Addendum #2

RE: QUESTIONS & ANSWERS, SPECIFICATIONS, DRAWINGS AND DOCUMENTS

Project
SICKKIDS - 7A SCHEDULE - 1BEDS REFRESH
ATRIUM (SLAUGHT) WING, 170 ELIZABETH STREET, TORONTO, ON, M5G 1E8

4 RENO FLOOR FINISH PLAN - LEVEL 7
SCALE: 1:50

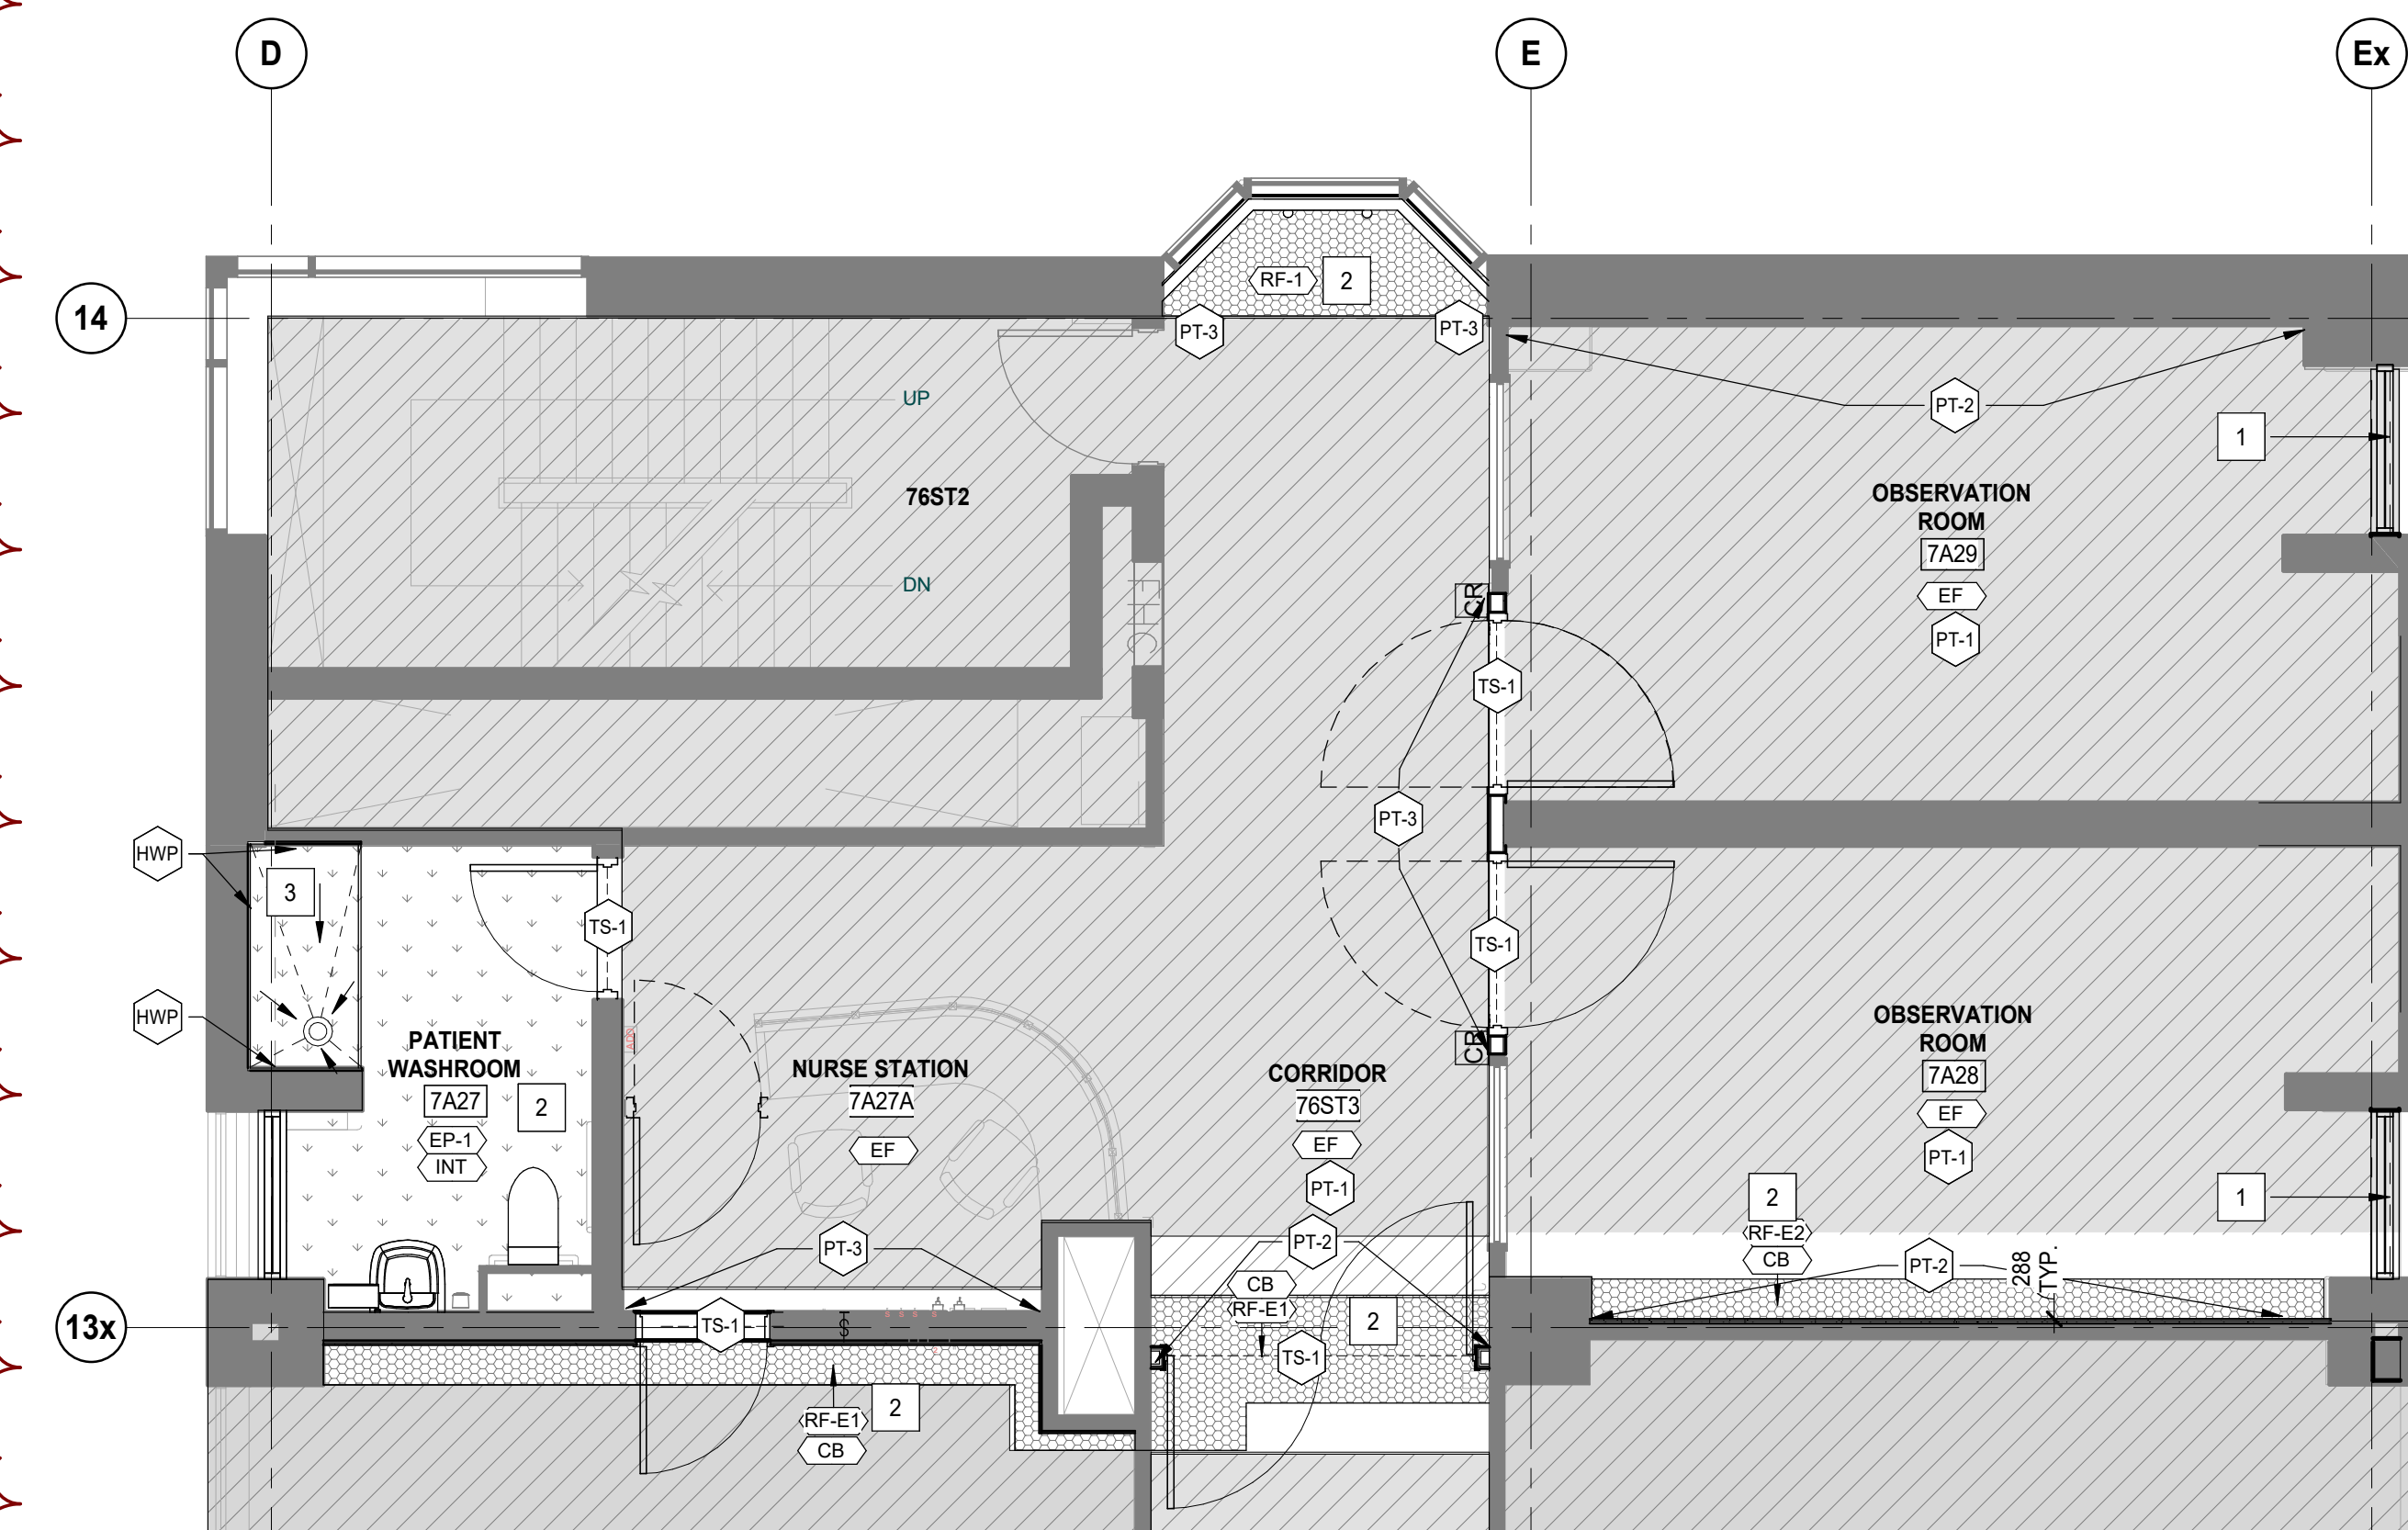
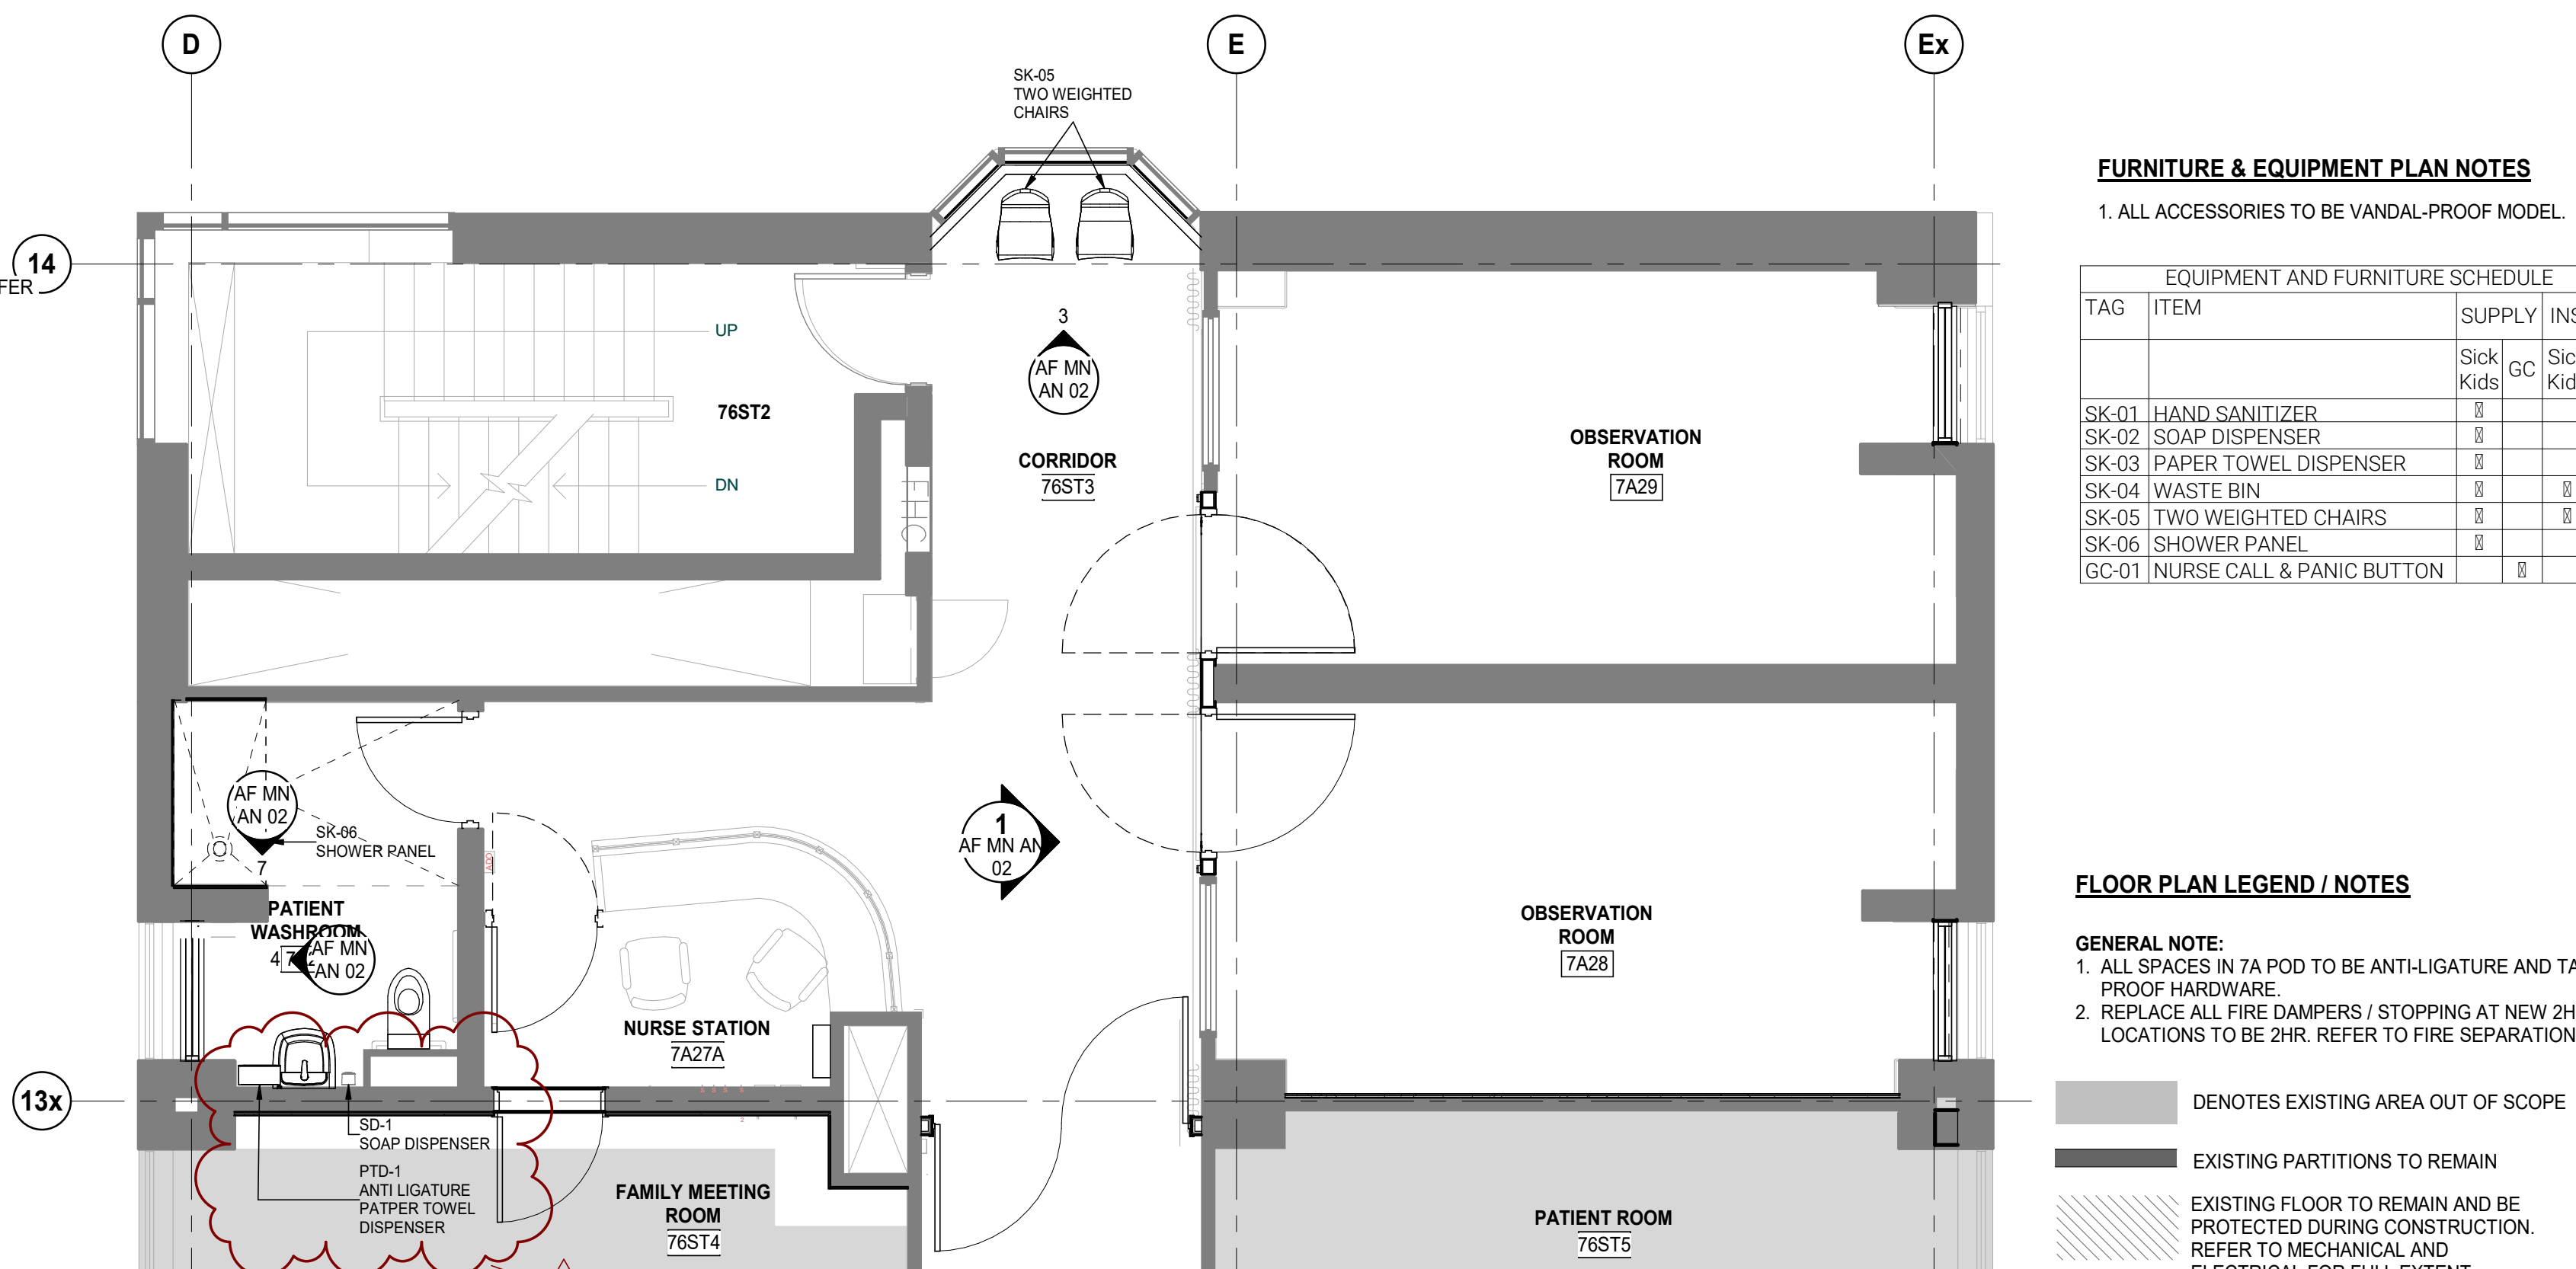
Q49- Reno Floor finish plan 6/AF 07 AN 01 calls for RF-1 floor patching at 4 locations. From the site visit it was noted the flooring at North & South end of corridor 76ST3 is the same grey as flooring in Nurse Station 7A27A, but the flooring in Observation room 7A28 was noted as being a different beige colour. Please clarify if all new floor patching is to be 1 colour or if we are to match existing flooring colour. If available, please provide the existing flooring manufacturer and colour selection.

Q60- Finish plan legend on 6/AF07AN01 calls for WP-1 protective partition covering with bumper rail to be matched with existing. Due to presence of staff and patients in the corridor area during the site visit, no photos of the corridor area or bumper rails were taken. Can a specification for new bumper rails be provided and clarify if bumper rails are to be anti-ligature.

A49- Refer to revised Drawings & List of Materials issued as part of Addendum 2.

A60- Refer to revised Drawings issued as part of Addendum 2, bumper rail requirement removed.
